Dunstan East
Washington Street
West Newton, Massachusetts

Site Plan

Dunstan East Peer Review
June 10, 2021

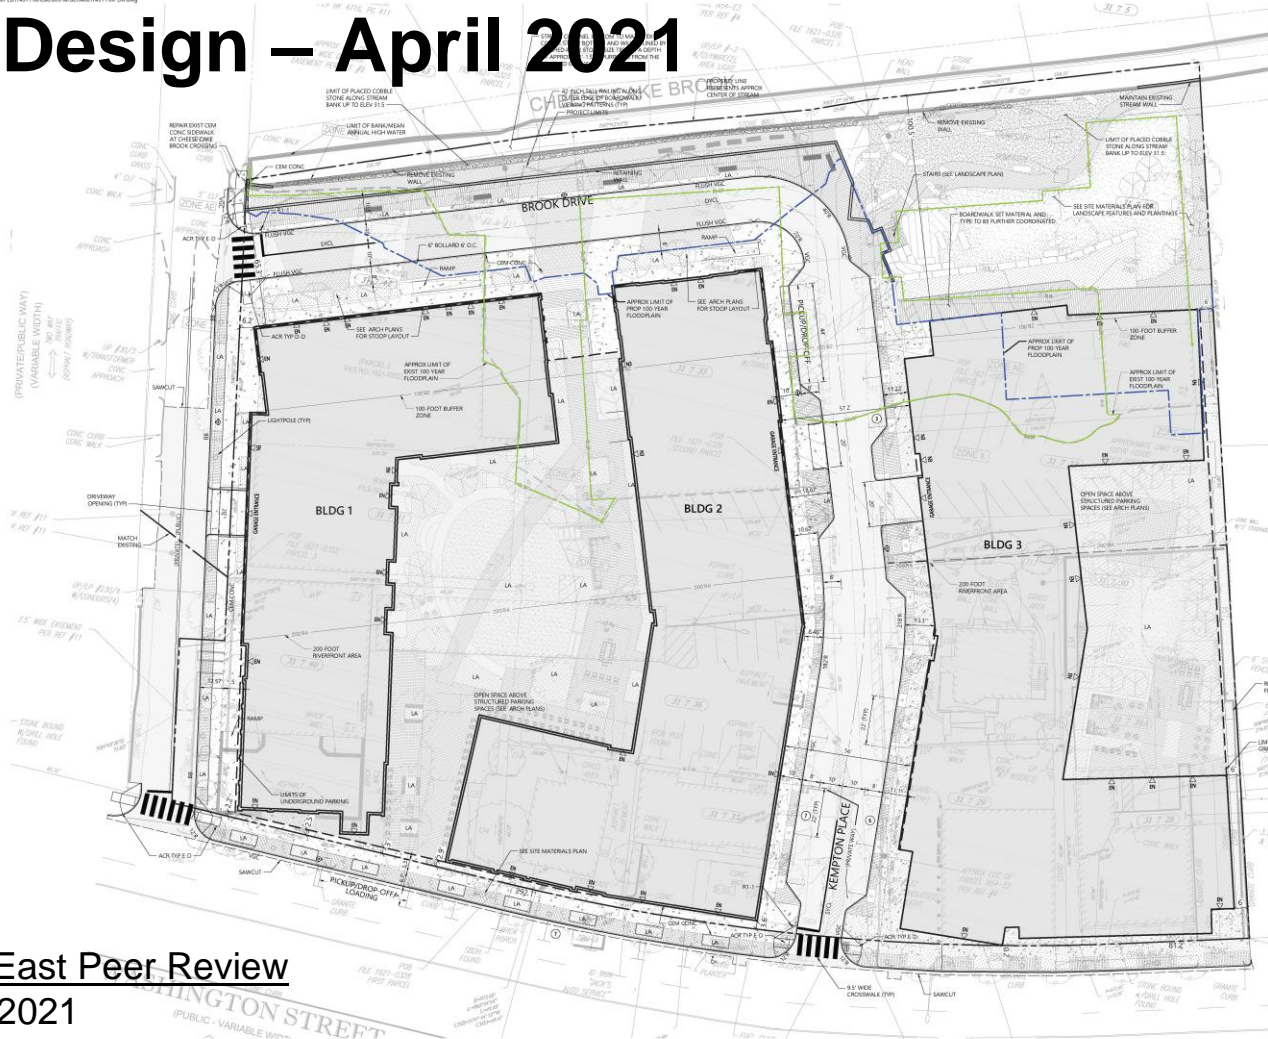
- Site framework is generally consistent with the 2020 submittal and the Washington Street Vision Plan:
 - Limit visible parking, make a more comfortable environment
 - Design streets & plazas as places to linger
 - Provide opportunities for public art, including music and community events
 - Improvements to Cheesecake Brook, reduce heat island & flooding
 - New and well-connected open spaces to break down block scale
- Kempton Place design updates are positive.
- Pickup/dropoff locations need coordination.
- Commitment to LEED Gold, EV stations, & solar ready.

- Brook Drive design details for flush condition & transitions.
- Kempton Place cross sections.
- Update courtyard exhibits.
- Trash/recycling, deliveries, and pickup/dropoff locations.
- Site design & photometrics clarifications.
- Shadow study.

- Development located within 200-foot Riverfront Area therefore required to meet Massachusetts Stormwater Management Standards.
- Increased Site Area from 3.3 to 3.6 acres from 2020 design.
- Revised proposed development reduces impervious by ~10,000 sf, therefore qualifies as Redevelopment.
- Redevelopment is required to meet MSWMS to the maximum extent practicable.
- Applicant is providing two sand filters to improve water quality. The sizes have been increased from the 2020 design to manage the additional site area.
- Plans, details, and calculations are not always consistent. Request revised documents to verify system will be constructed as designed.

- Development is located within Bordering Land Subject to Flooding.
- During 100-year flood Cheesecake Brook overtops existing parking lot.
- Applicant is required to provide storage equal or greater than existing on a foot-by-foot basis.
- Applicant is providing storage within proposed open space in northeast corner.
- The compensatory flood storage calculations need to be revised once the architectural design and landscaping design area are finalized.
- Require additional documentation for Building 3 and the intended piers to verify that the Applicant is providing adequate flood storage beneath the building.

- Property boundary is the centerline of Cheesecake Brook.
- Cheesecake Brook is contained on both sides by stone walls.
- Applicant is proposing to remove most of the existing stone wall along the south side of Cheesecake Brook from Dunstan Street to the property boundary.
- Applicant is working with Charles River Watershed Association.
- Encourage the Applicant to continue to coordinate with CRWA to remove the wall and integrate the brook into the landscaping features.
- 60-inch pipe carries stormwater from the Mass Turnpike to Cheesecake Brook. Erosion control and long-term maintenance will be required.
- Applicant is providing some improvements associated with the outfall of the 60-inch pipe to reduce erosion into Cheesecake Brook.
